ADDENDUM 1

DATE: 01/30/18
PROJECT: UCT Expansion Interior Buildout
RFP NO: RFP 744-R1805 – UCT Expansion Interior Buildout
OWNER: The University of Texas Health Science Center at Houston
TO: Prospective Proposers

A401

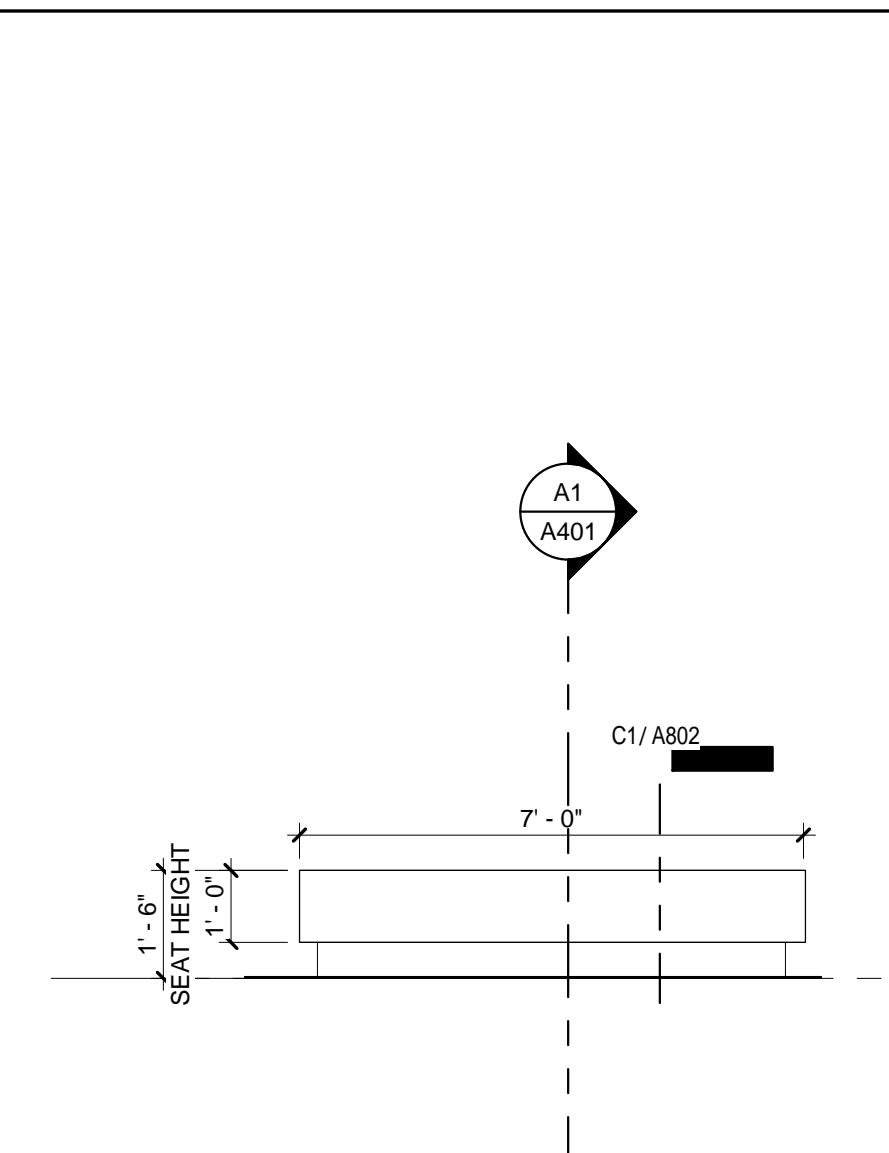
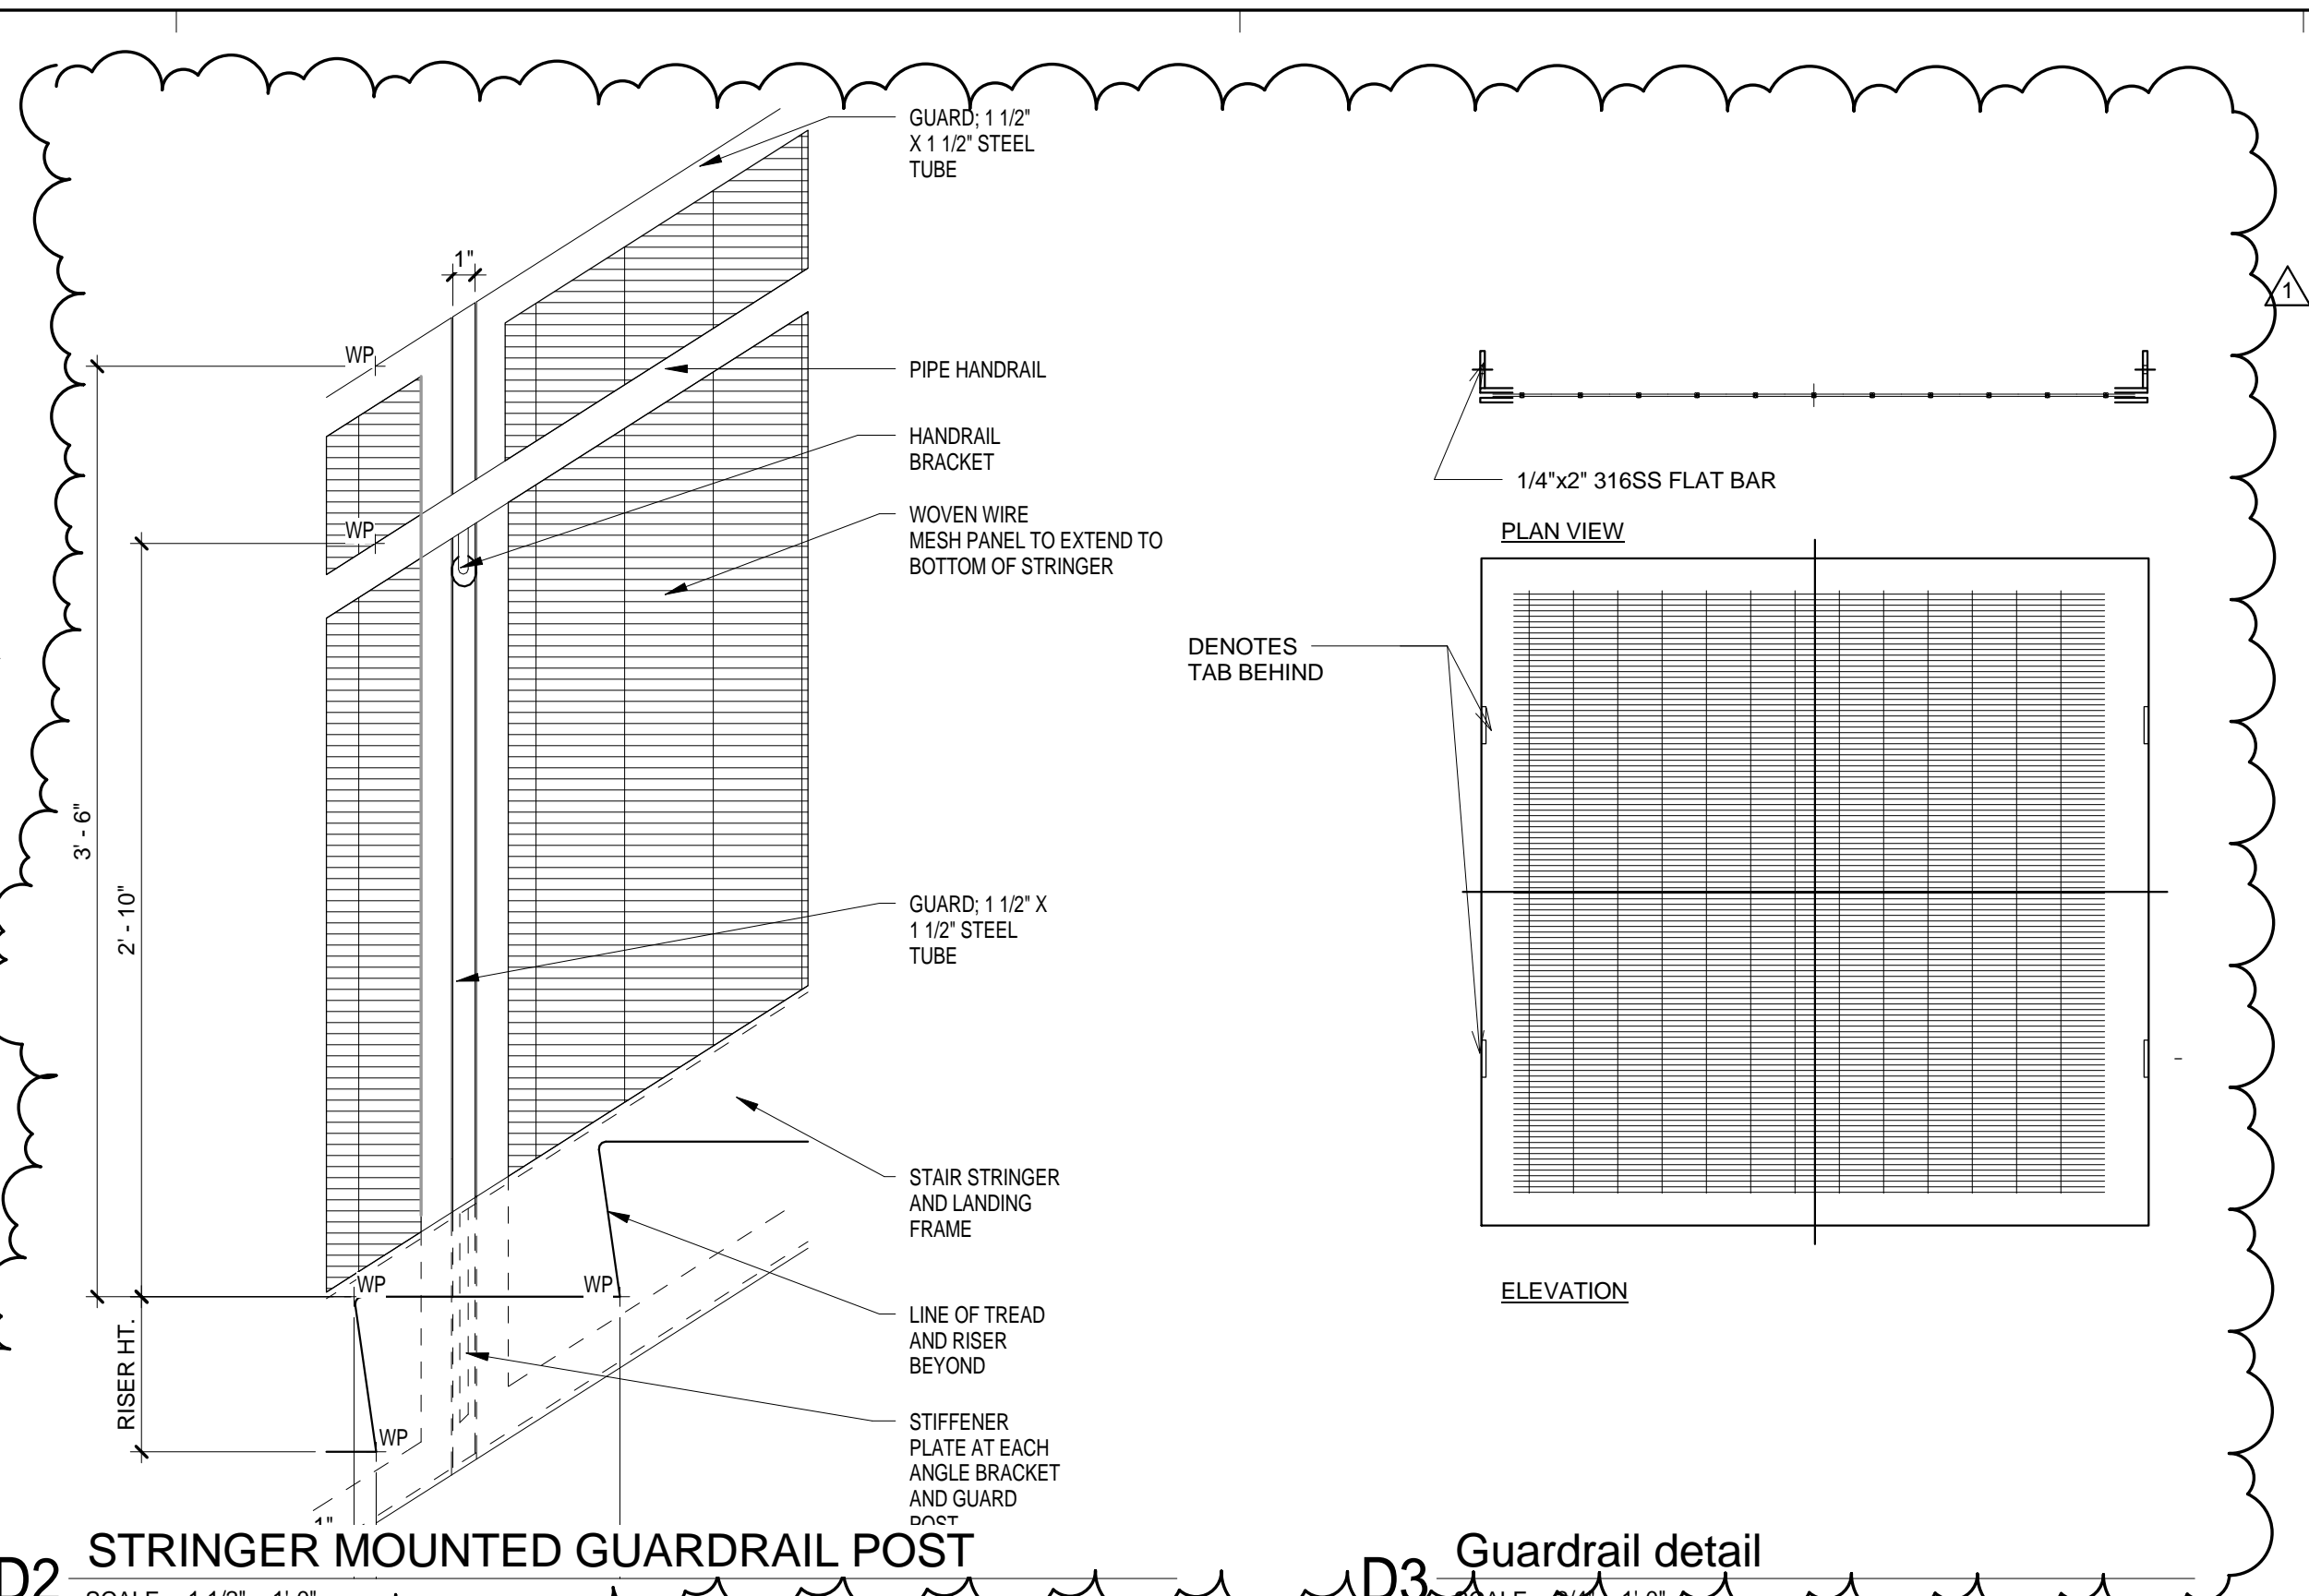
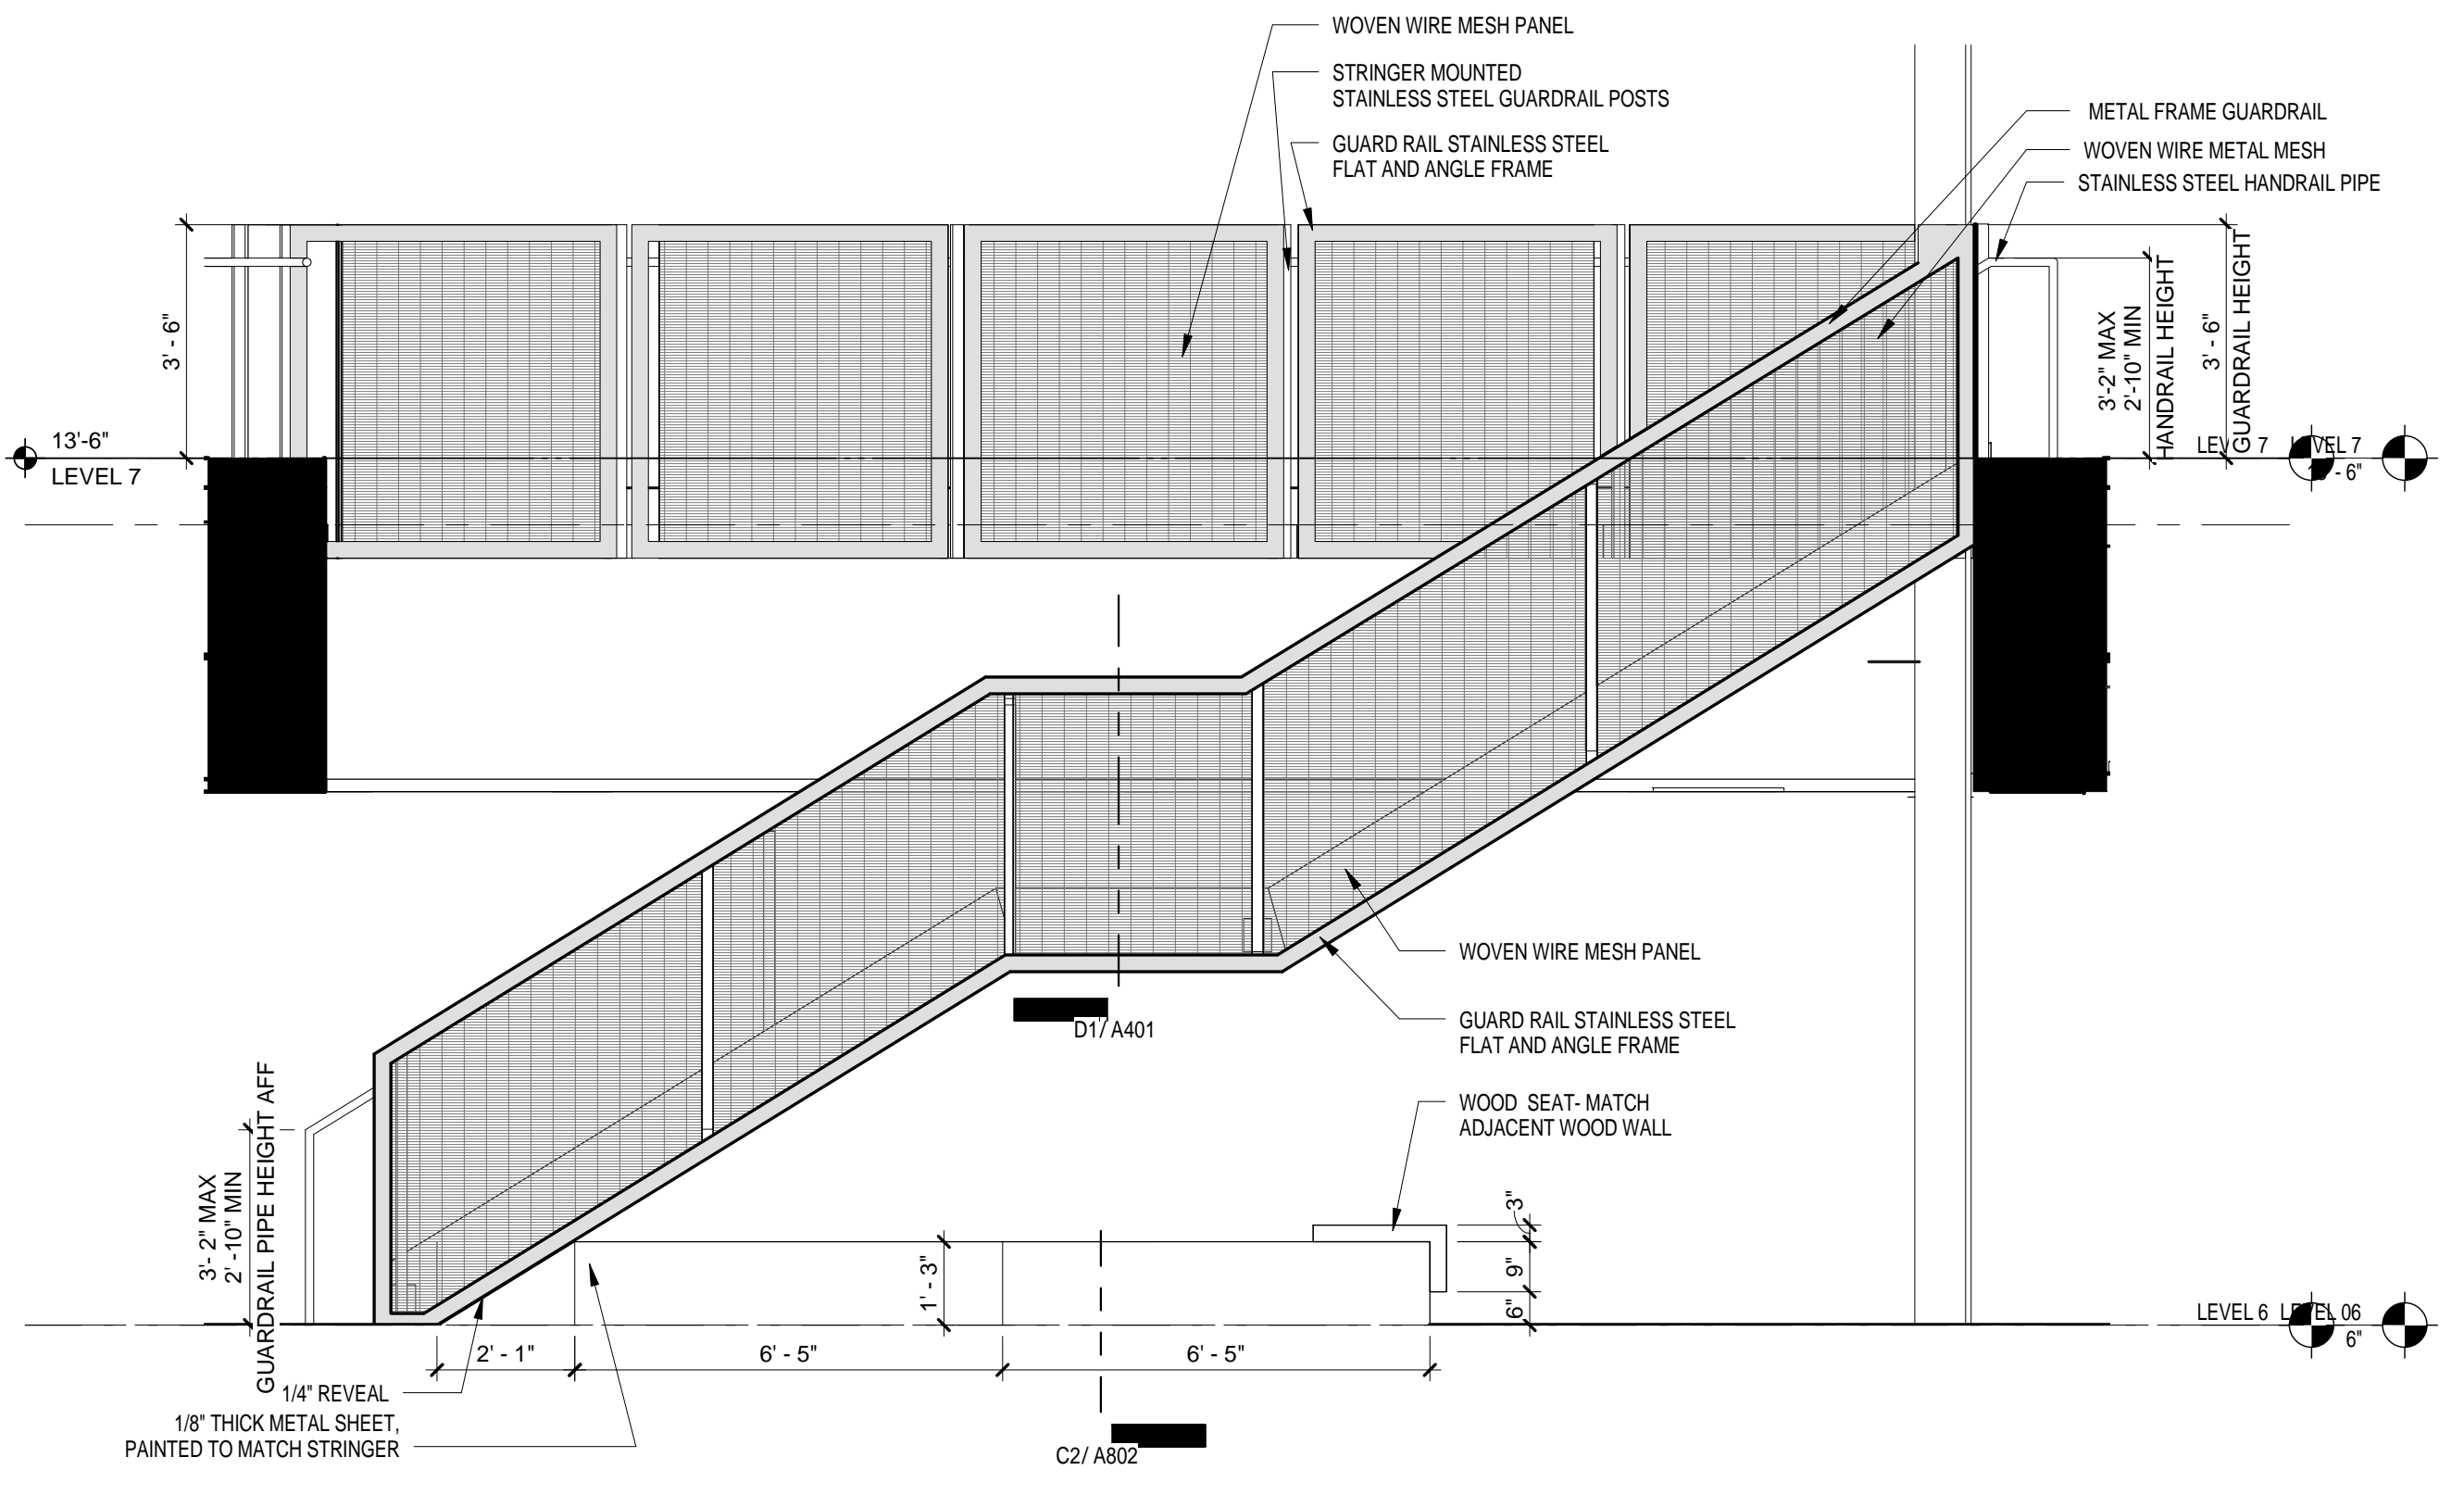
31. Sheet A401 – Please provide the following clarifications:

a. Detail C1 – Please provide detail for Guard Rail Stainless Steel “Flat and Angle Frame”

b. Detail C3 – Please clarify how mesh support tubes are mounted to the stringers.

c. Detail C3 – Detail indicates stainless steel fascia. Please clarify if this fascia is existing or part of this project installation. If part of this project, please provide details and location of stainless steel fascia.

d. Please clarify handrail. Details A1 & C1 indicate a single line rail, while A3 & D1 indicate a 4-line rail.

Provided

Vertical Support tubes to be mounted on stair stringer see drawing for notes

Stringer part of the core and shell project. No Steel Fascia to be used.

Single line handrail is to be provided

All details to be provided in Addendum 1 documents

32. Sheet A401 – Detail C5 indicates wood flooring to match existing stair treads. Please provide wood floor material selection and specifications.

a. Is the extent of the wood flooring to be the hatched square shown in this detail only?

Flooring and treads will be added into the interior Buildout set in an Addendum.
1 1/2" WALNUT WOOD TREAD
